SERVICE CAMPAIGN BULLETIN

CAMPAIGN REF: 01D
TITLE : Retrofit noise insulation to the cooling fan relays
DOCUMENT # : 11 E 001

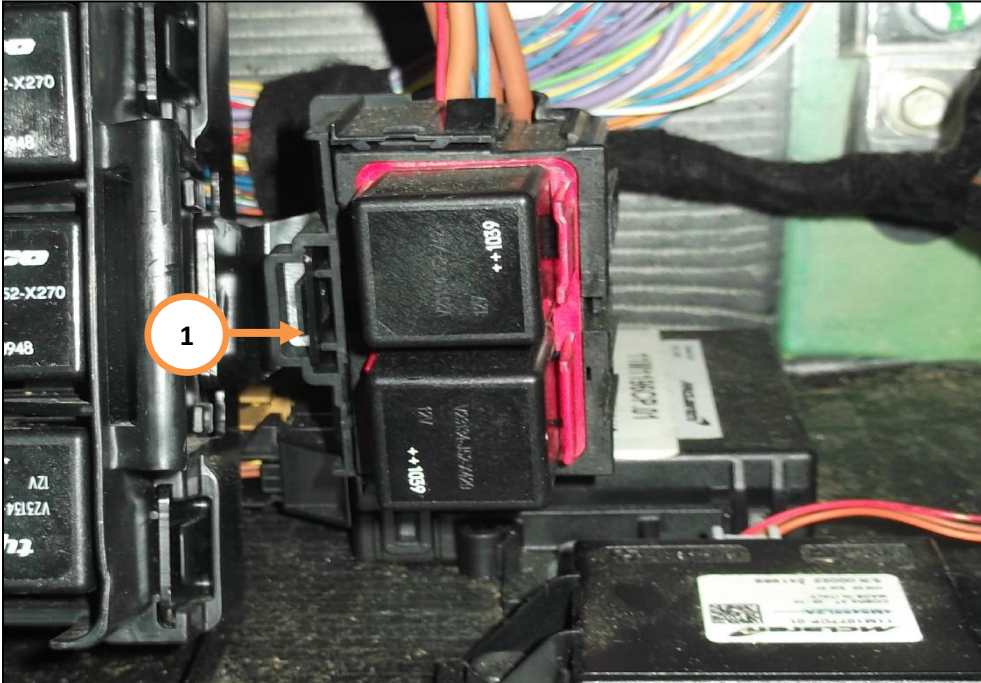
SITUATION : Quality Engineering at McLaren Automotive have identified that the noise produced by the cooling fan relays when switching is excessive.

PROCEDURE : Retrofit 11M2360CP – NVH cover to the cooling fan relay.

6. Detach the cooling fan relay base from its mounting position (1).
7. Secure the insulation to the relay as illustrated on the following pages.

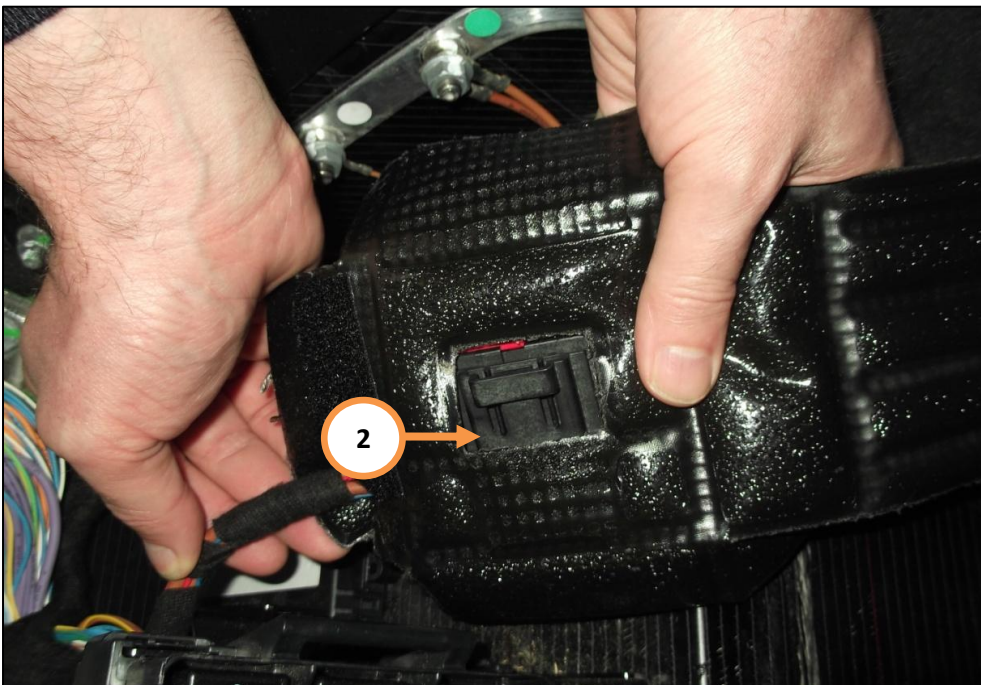
8. Insert the relay base mounting through the insulation pad (2).

9. Fold the insulation pad around the relays as per the remaining illustrations below.

10. Refit the relay holder to the mounting bracket.
